Model: Mojito		Date: 14-Apr-00	No.: RA293001
Subject: Software Update for Mail Box CS360		Prepared by: A. Sasaki	
From: Technical Service Dept., GTS Division			
Classification:	<input type="checkbox"/> Troubleshooting <input type="checkbox"/> Part information <input checked="" type="checkbox"/> Action required <input type="checkbox"/> Mechanical <input type="checkbox"/> Electrical <input type="checkbox"/> Service manual revision <input type="checkbox"/> Paper path <input type="checkbox"/> Transmit/receive <input type="checkbox"/> Retrofit information <input type="checkbox"/> Other ()

Model: Mojito		Date: 19-May-00	No.: RA293002
Subject: LG kit (8 1/2"x14"paper size tray Installation procedure and parts catalog		Prepared by: F. Noguchi	
From: Technical Service Dept., GTS Division			
Classification:	<input type="checkbox"/> Troubleshooting <input type="checkbox"/> Mechanical <input type="checkbox"/> Paper path <input type="checkbox"/> Other ()	<input type="checkbox"/> Part information <input type="checkbox"/> Electrical <input type="checkbox"/> Transmit/receive	<input type="checkbox"/> Action required <input checked="" type="checkbox"/> Service manual revision <input type="checkbox"

Page 2-18

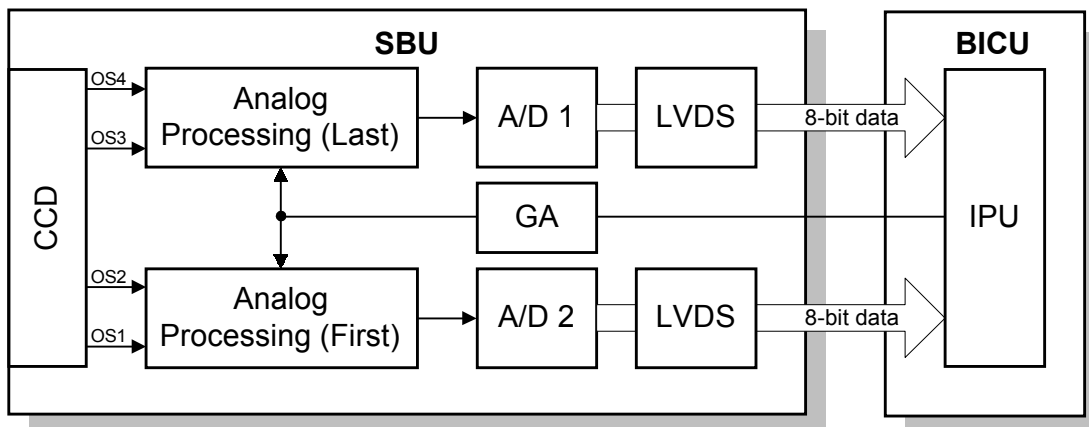
Please replace this page with the following explanation.

The CCD converts the light reflected from the original into an analog signal. The CCD line has 7,500 pixels and the resolution is 600 dpi (23.6 lines/mm).

The CCD has four output lines: OS1, OS2, OS3, and OS4. OS1 and OS2 are for the first half of the scan line (Non-operation side), and OS3 and OS4 are for the last half of the scan line (Operation side). There are two analog processing ICs; one handles the first half line (OS 1 and OS2) and the other handles the last half line (OS3 and OS4). The analog processing IC performs the following operations:

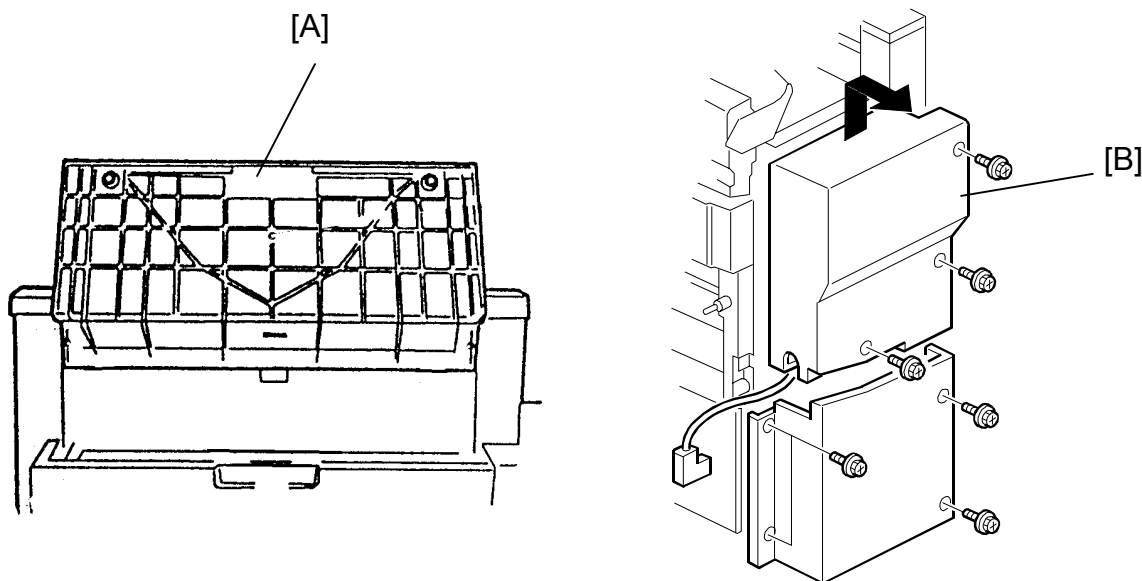
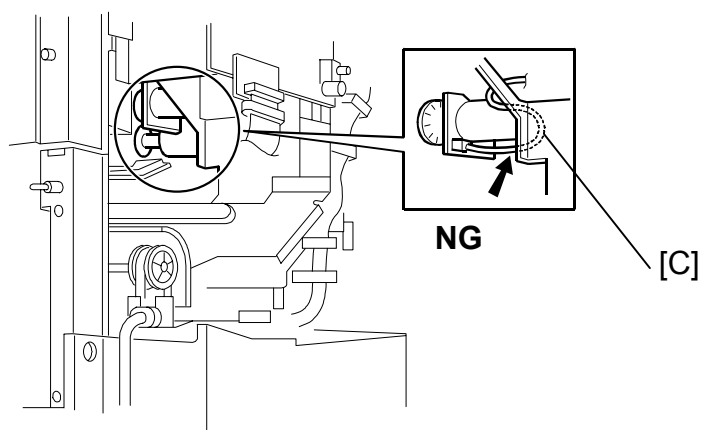
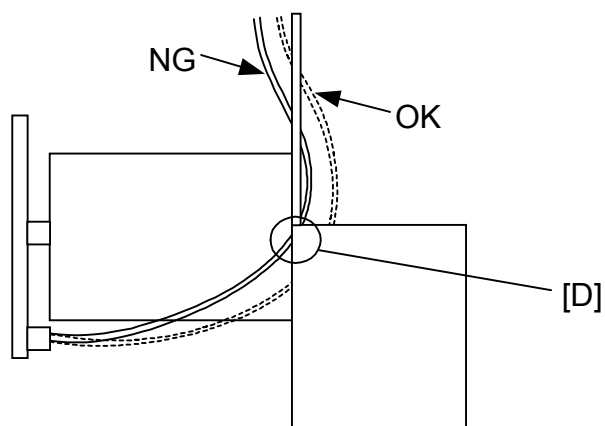
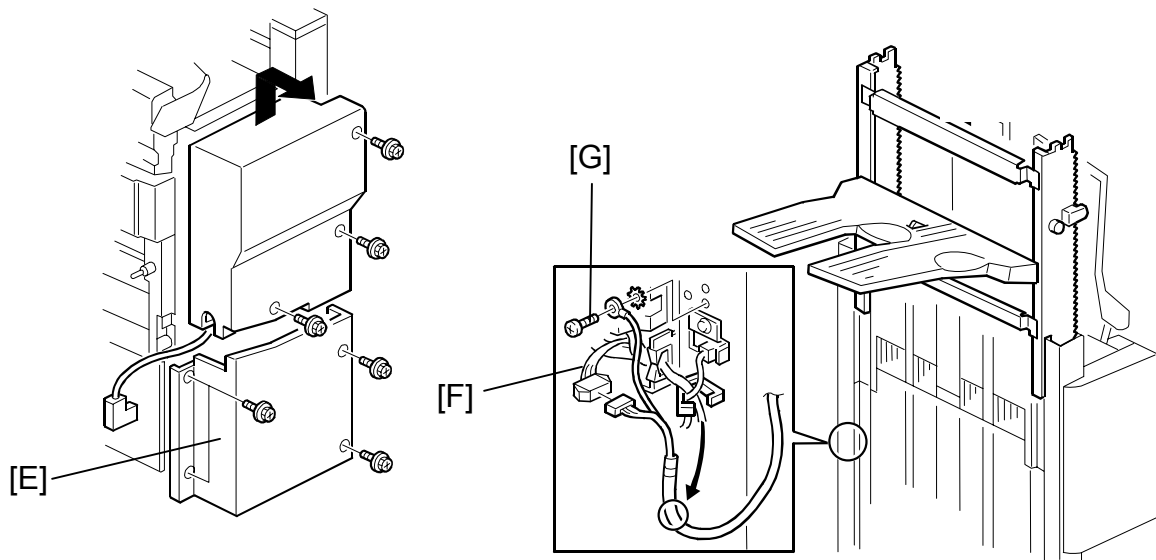
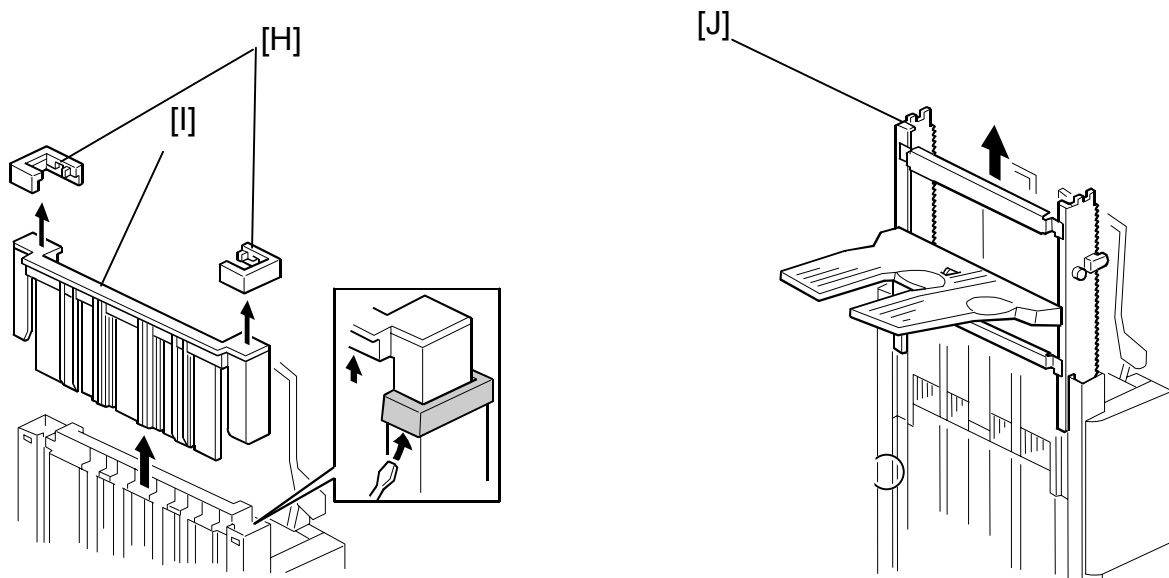
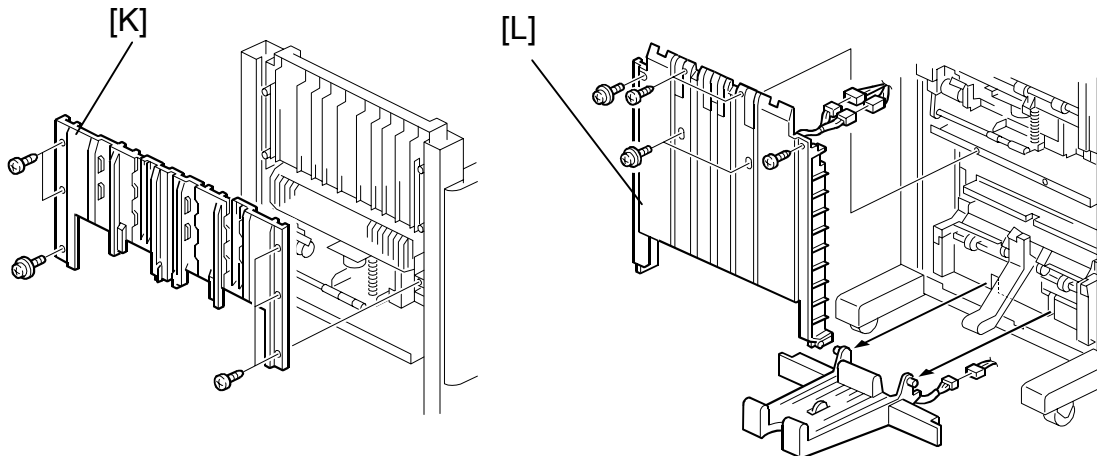
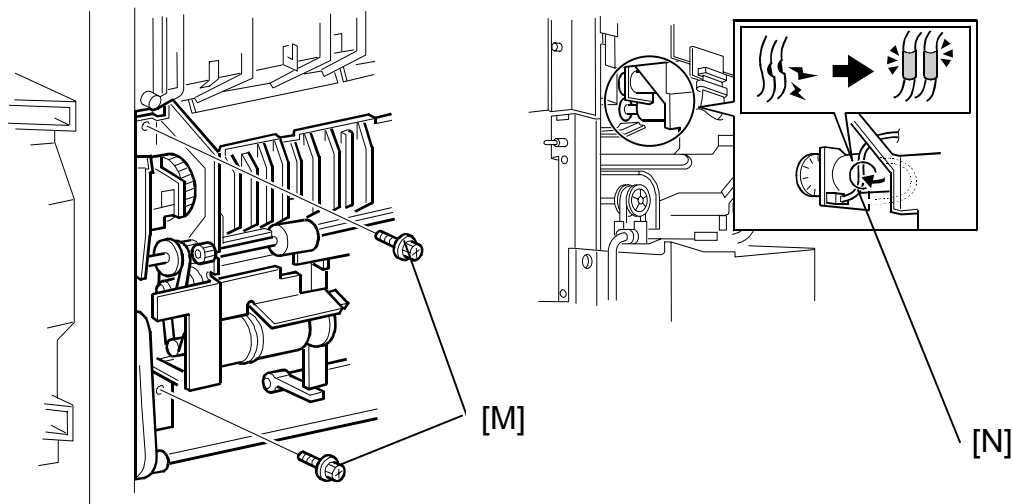
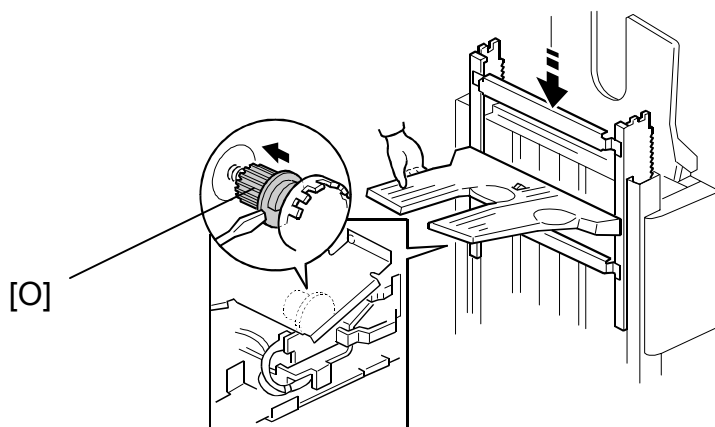
When making copies in staple mode, an IC on the finisher board shorts and SC740 is displayed. After the main switch is turn off and on, a jam is indicated.

The cable of the guide plate motor is caught between the guide plate unit and frame. In the worst case, the cable covering peels off and the +24V line is shorted to ground. These two factors combine to cause the finisher board to be damaged.

1. Hold up the proof tray and open the top cover [A].
2. Unhook the upper rear cover [B] and remove it (3 screws).

3. Check to see if the cable [C] is caught.

6. Remove the lower rear cover [E] (4 screws).

7. Disconnect the connector [F] and remove the grounding wire [G] (1 screw).

10. Remove the upper shift guide [K] (6 screws (5 x M4, 1 x M3)).
11. Remove the lower shift guide [L] (2 connectors, 6 screws [3 x M4, 3 x M3]).

The length of the cable has been decreased and the route of the cable has been modified.

No.: RA293009a

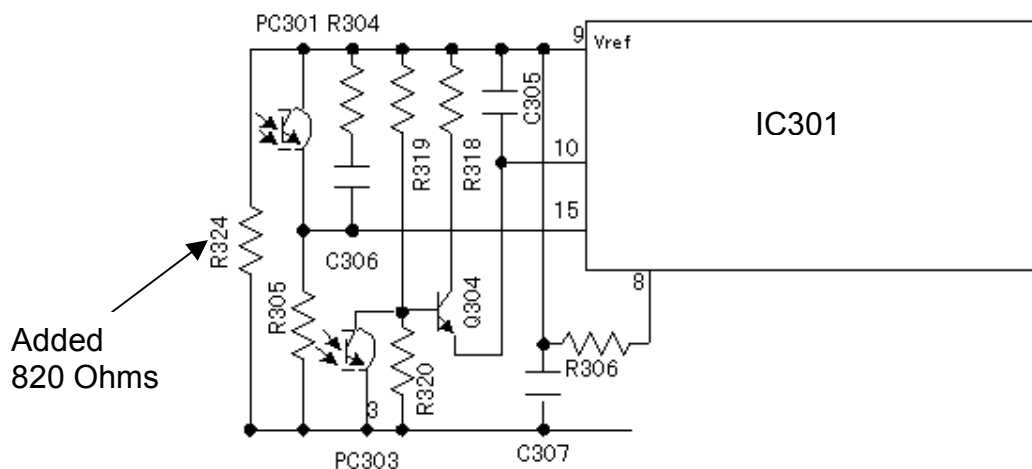
Note: The PSU boards themselves cannot be modified in the field. Therefore, all PSUs now in service parts stock are either modified units or previous units that were found to have no problems (see below for details). The part number for the PSU has not been changed.

An 820 Ohm (1/4w) resistor has been added to the PSU board. In order to do this, the board pattern was changed.

Field Modification Procedure

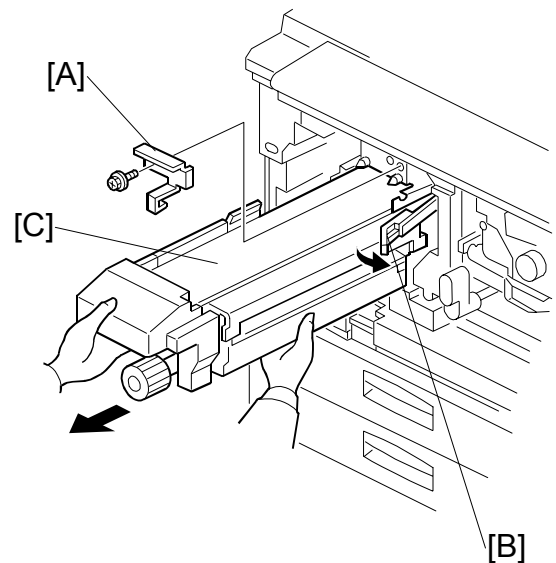
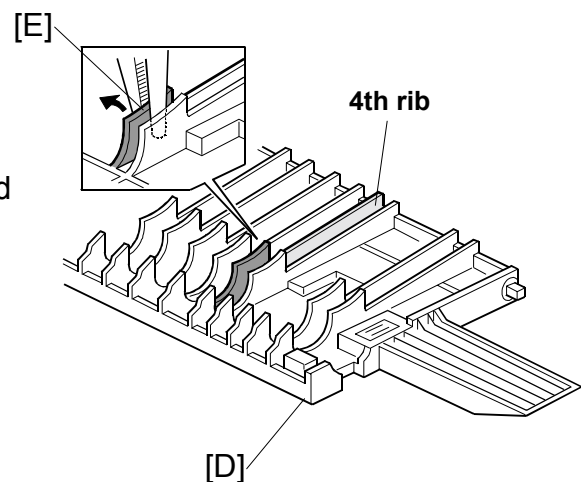
At installation or the next customer visit, please use the following procedure to check if there is an extra rib on the upper exit guide cover. If there is, please remove portion [E] as shown below.

1. Turn off the main power switch.
2. Open the front door.
3. Remove the stopper [A] (1 screw).
4. While releasing the lever [B], pull out the fusing unit [C] as shown.

5. Open the exit upper guide plate [D].
6. If the plate contains the extra rib shown in the illustration (4th rib from the front), bend the high end (dark shaded area) [E] toward the back at its base, breaking it off.
7. Reassemble the machine.

SOLUTION

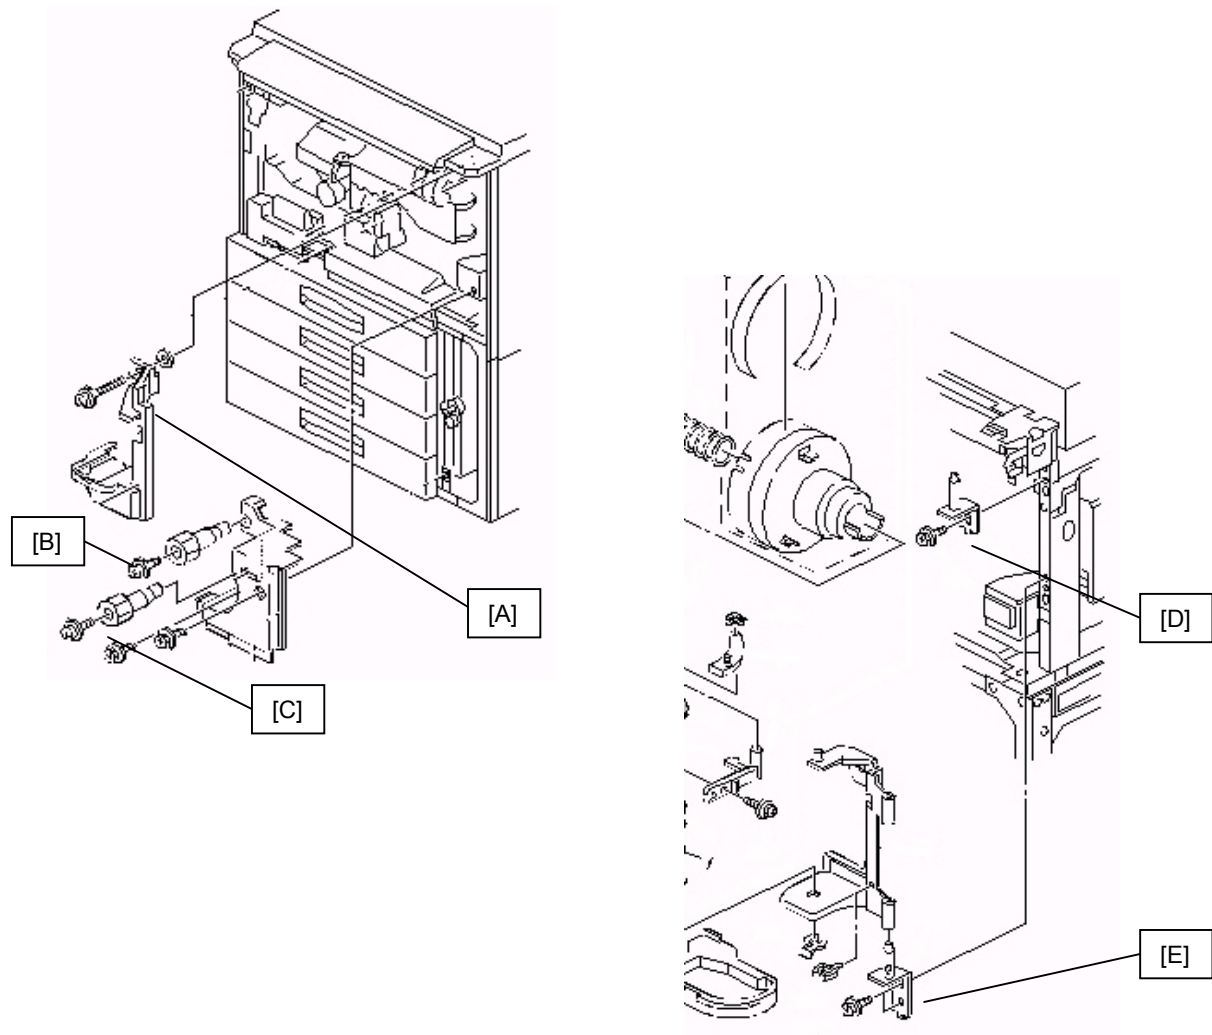
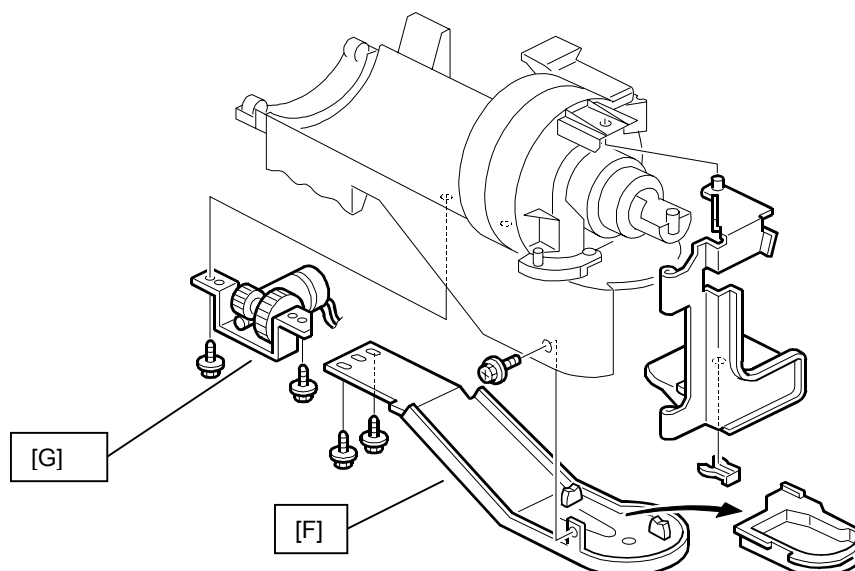
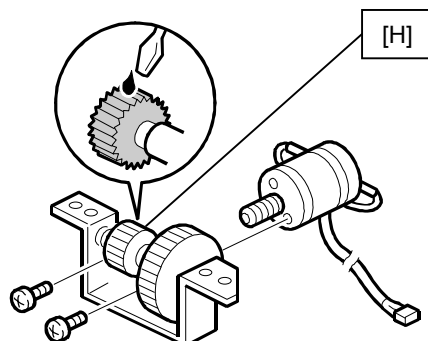
An increased amount of grease has been applied to the gear at the factory since the first lot of May 2001 production.

1. Remove the toner bottle.
2. Remove the right inner cover [A] (1 screw, 1 nut).
3. Remove the registration roller knob [B] (1 screw).
4. Remove the right lower inner cover [C] (2 screws).
5. Disconnect the DC motor connector.
6. Remove the contact point stay [D] (1 screw).
7. Remove the lower hinge [E] (2 screws).
8. Remove the toner bottle holder assembly.

9. Remove the turn bracket [F] (3 screws).
10. Remove the toner bottle bracket [G] (2 screws).

11. Apply the grease to the contact surface of the Motor Joint Gear [H].

Subject: Tandem Tray Modification

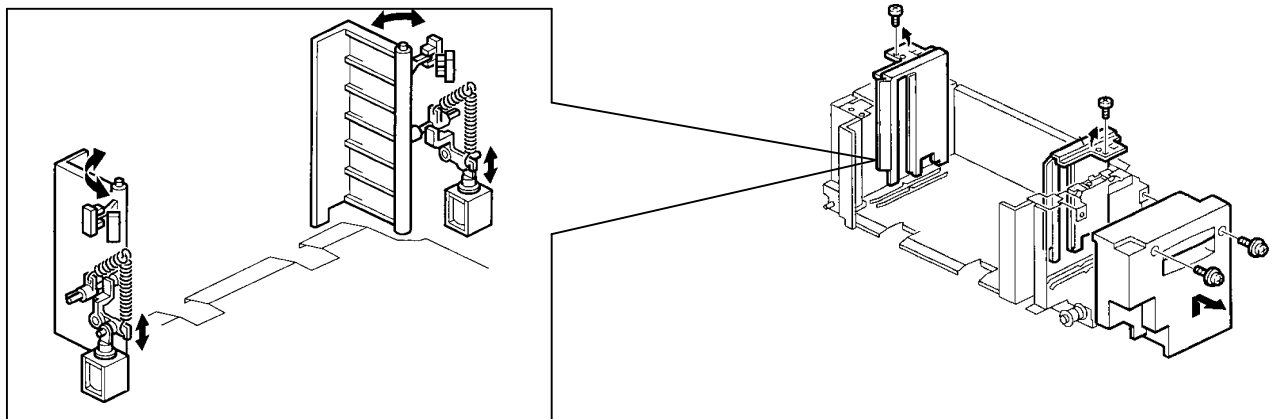
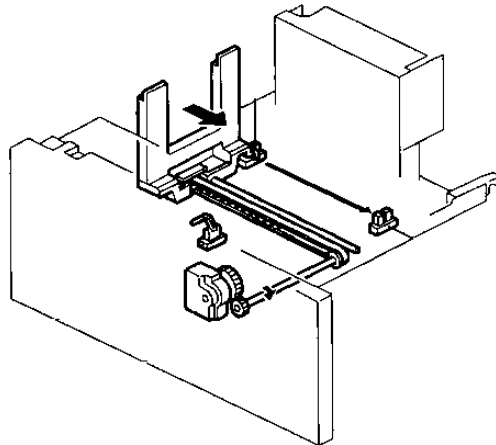
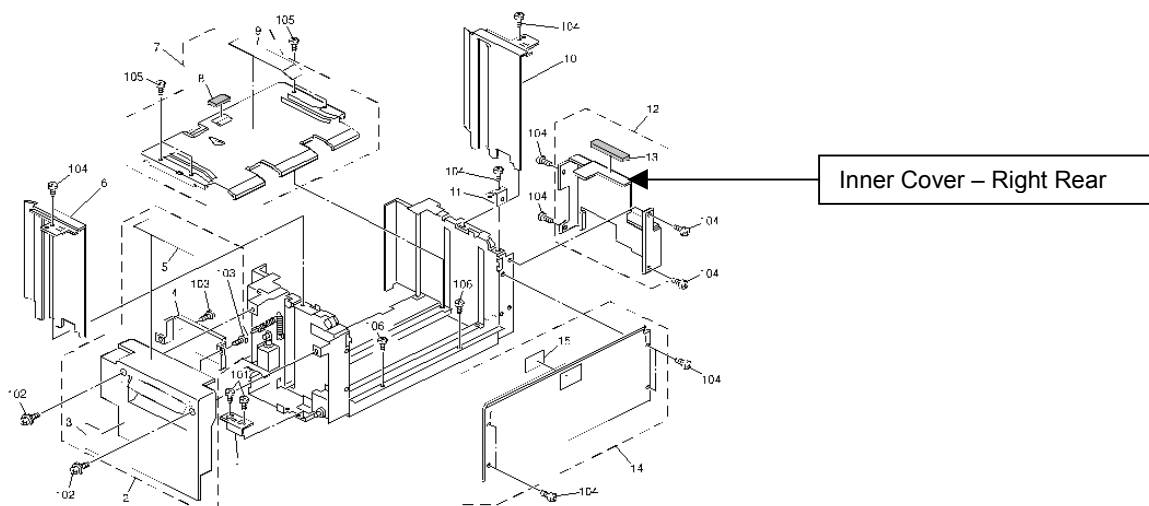
- Right tray does not lift up.
- Left tray back fence is damaged.

The shock of closing the left tray (or incorrect paper loading) causes the right side fences to open, which in turn causes the left back fence to move to the right (attempting to shift the paper over to the right tray). When there is paper in the right tray, the left back fence is damaged from the resulting resistance.

A cushion (shock absorber) has been added to the right rear inner cover of the right tray.
→ Applied from the middle of May 2001 production.

The mask ROM software for the tandem tray has been changed so that the left tray back fence does not move, even when the right tray side fences are open.

The shape of this part has been changed. In addition, a cushion has been added to this part for shock absorption.

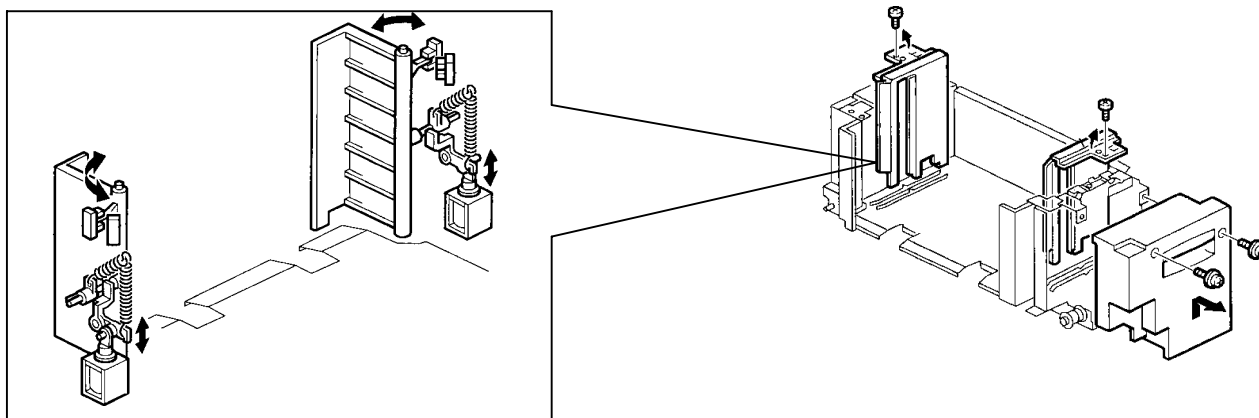
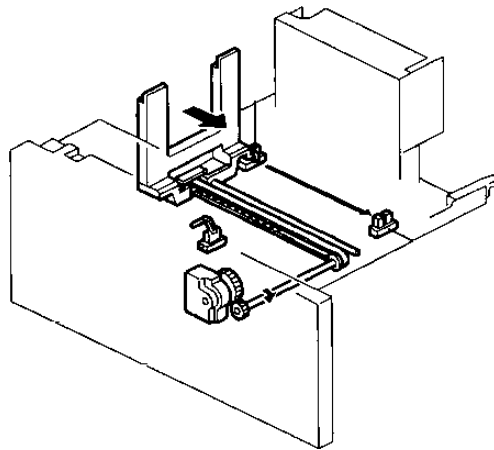
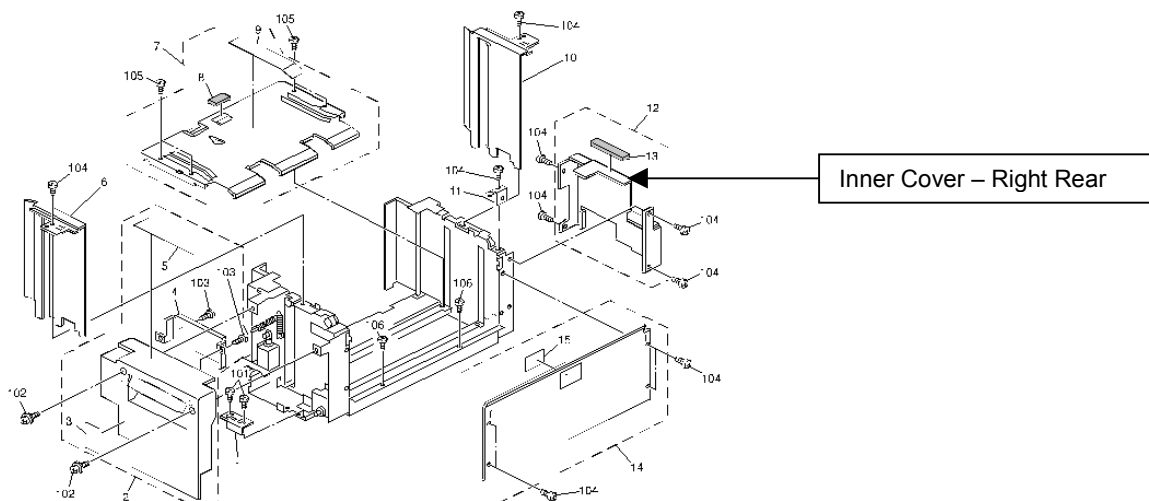
- Right tray does not lift up.
- Left tray back fence is damaged.

A cushion (shock absorber) has been added to the right rear inner cover of the right tray.
→ Applied from the middle of May 2001 production.

The shape of this part has been changed. In addition, a cushion has been added to this part for shock absorption.
